## **STAFF REPORT**

PLANNING COMMISSION

DATE: 1/22/24

**AGENDA ITEM:** PUBLIC HEARING - Preliminary Plat/Planned Unit Development request by At Home Apartments

34 OF 38

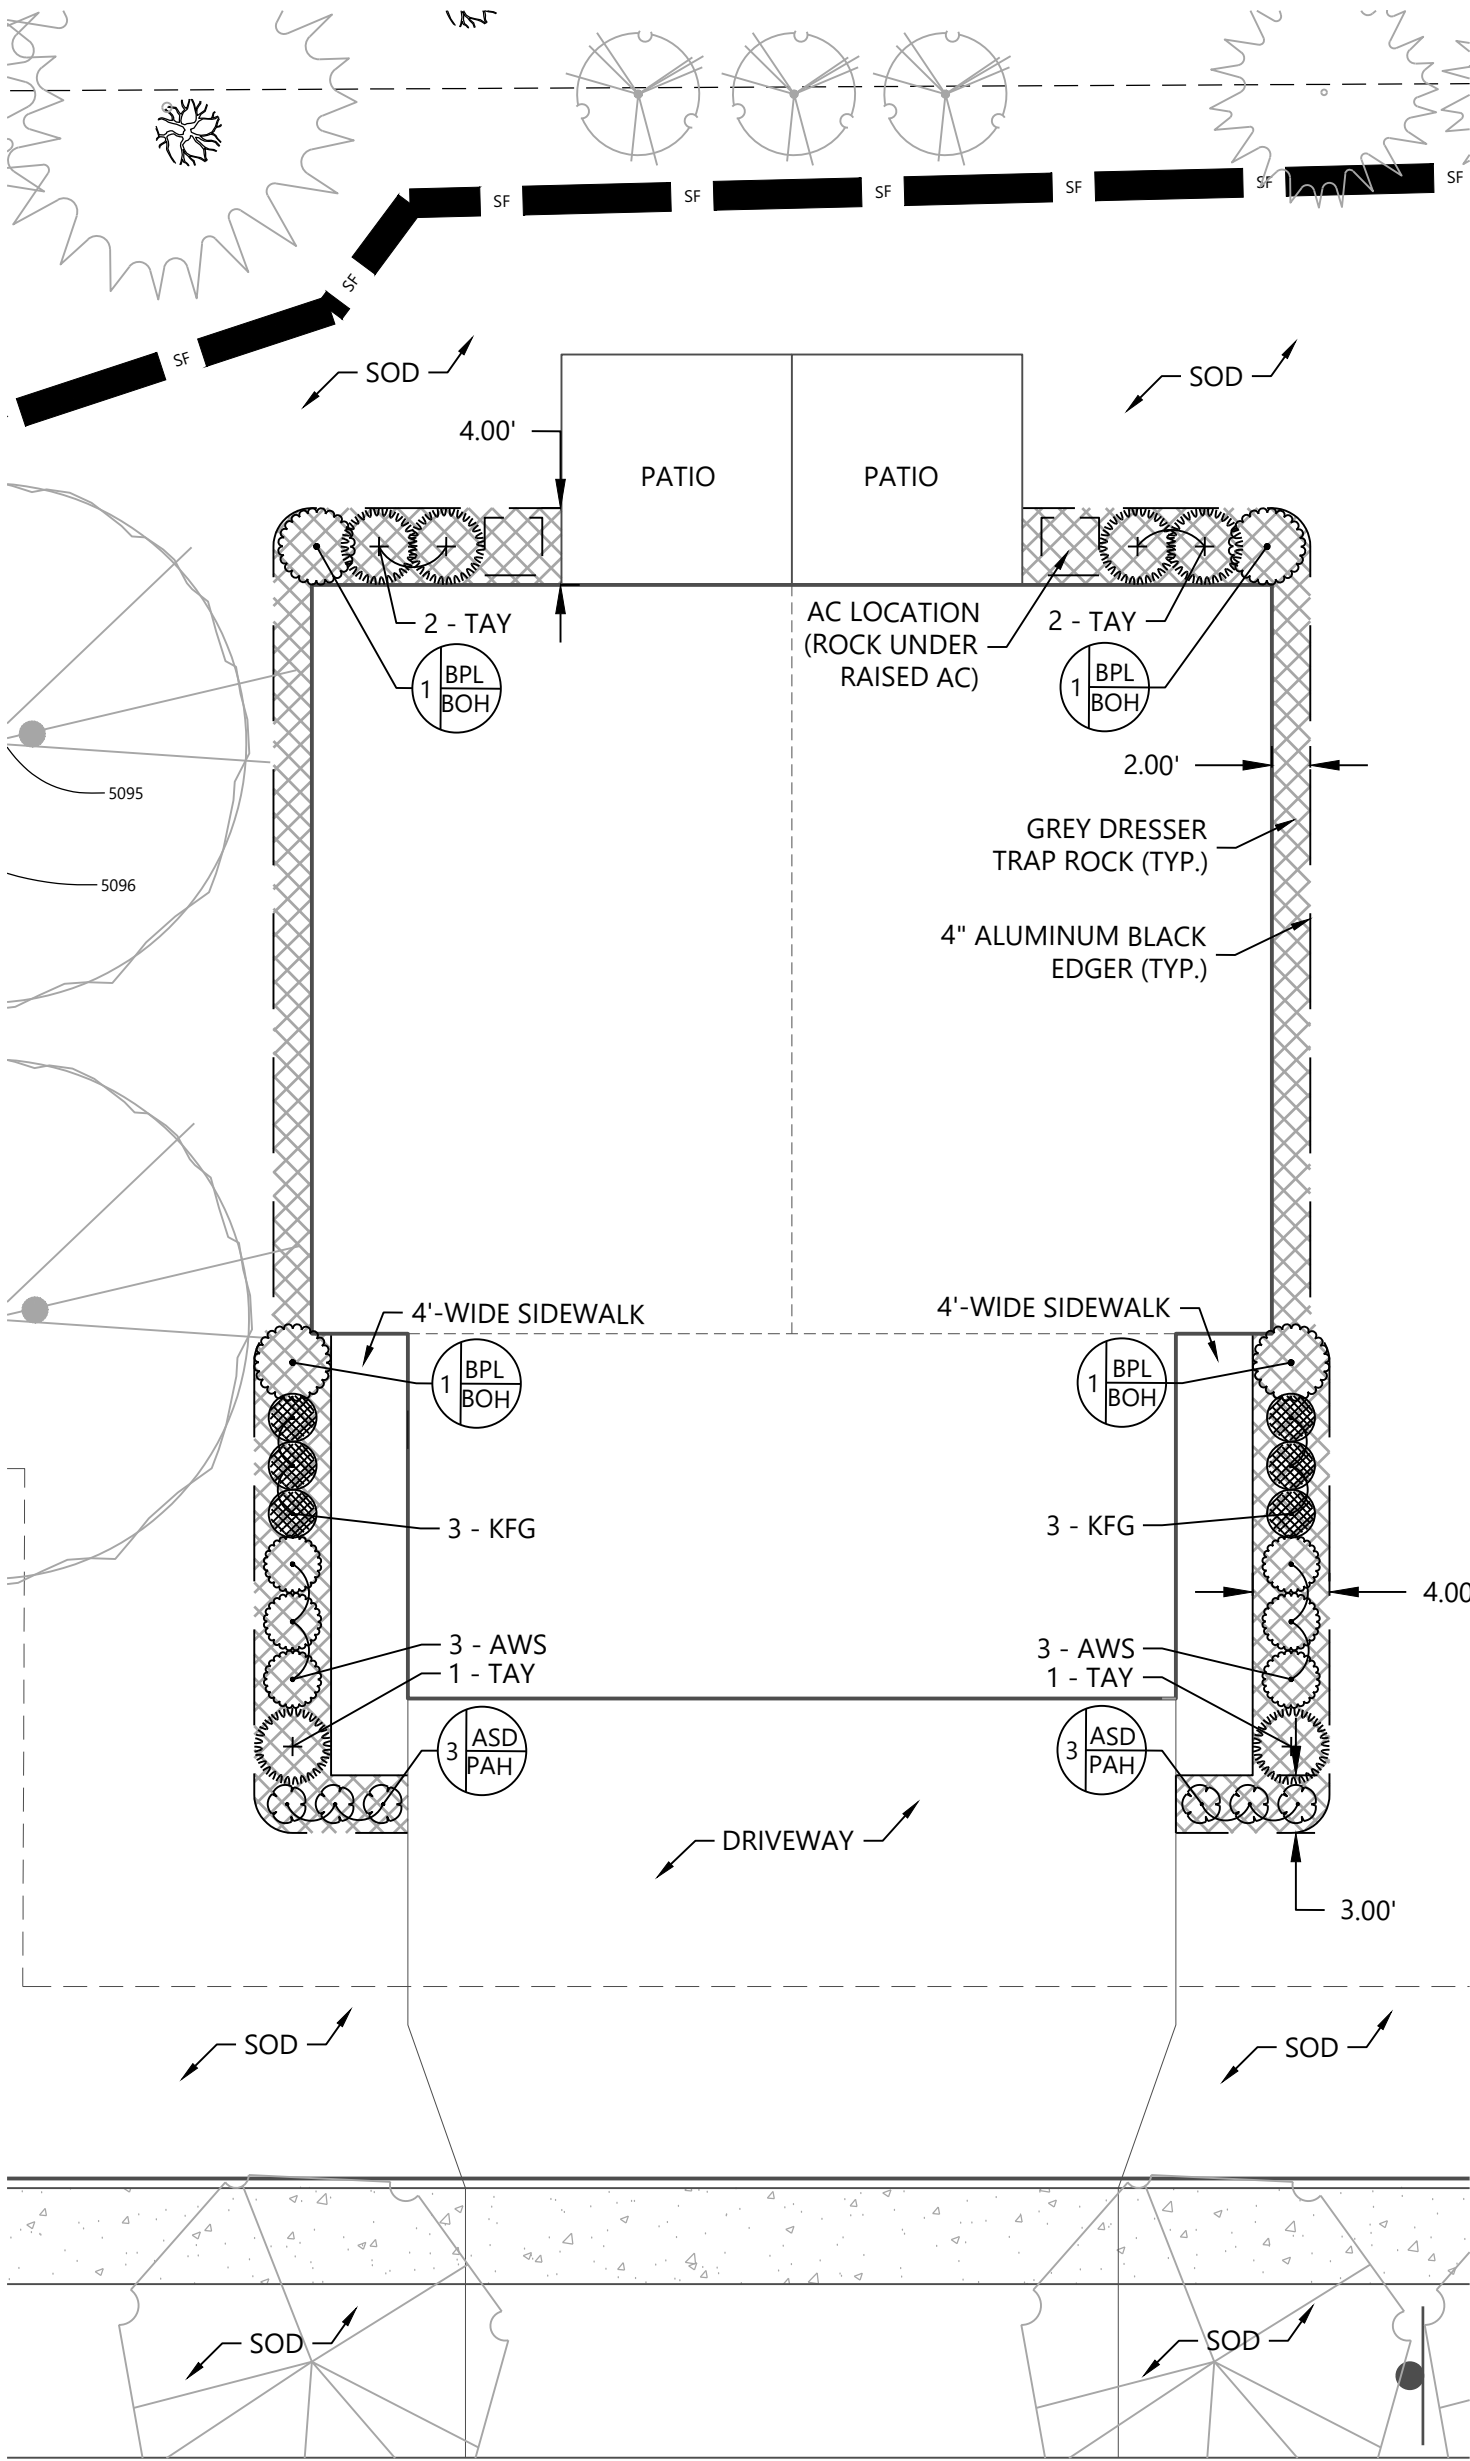
- Response: Utilities are detailed. Please see Sheet 34.
- Adjust hatches on the groundcover sheet legend to match the plan (it is unclear where the gabion rock is on the plan, what the planting beds are mulched with, and the wetland seed mix hatch is not scaled the same in the legend and on the plan, making it hard to read).

- The plant schedule needs to include height and spread of each plant type at the time of planting and at maturity.
  - Response: Please see updated plan schedule on Sheet 34.

- Minimum tree sizes for deciduous trees at 2.5”
  - Response: Please see Sheet 34.
- Include a table that summarizes the total trees required by code, to include: (1) linear feet street frontage and required street frontage trees (1 per 50lf) (2) total development acres and required development trees (5 per acre) (3) a least 1 tree per 40 linear feet as part of screening required between the development and less intensive uses (the single-family homes along the northern edge of the parcel) (4) total mitigation trees required (24, or an updated number based on tree preservation plan)

- Response: Hatches have been adjusted for easier identification. Notes have also been added for further clarification. Please see Sheet 34.
- The landscape plan must include a topsoil preservation plan that identifies a stockpile location and other requirements per 101.12.480(a) (9) and (h).

- Response: Please refer to the updated table provided on Sheet 34.
- Add screening required by code along the northern edge of the property between this development and the existing single-family homes. Show on the plan and illustration in elevations a 6’ wall or fence that is 90% or more opaque year-round between the two-land used, with trees at a minimum of every 25’ along the property line. See examples of screening graphics required in 105.12.480(f)(1-2) of the code.
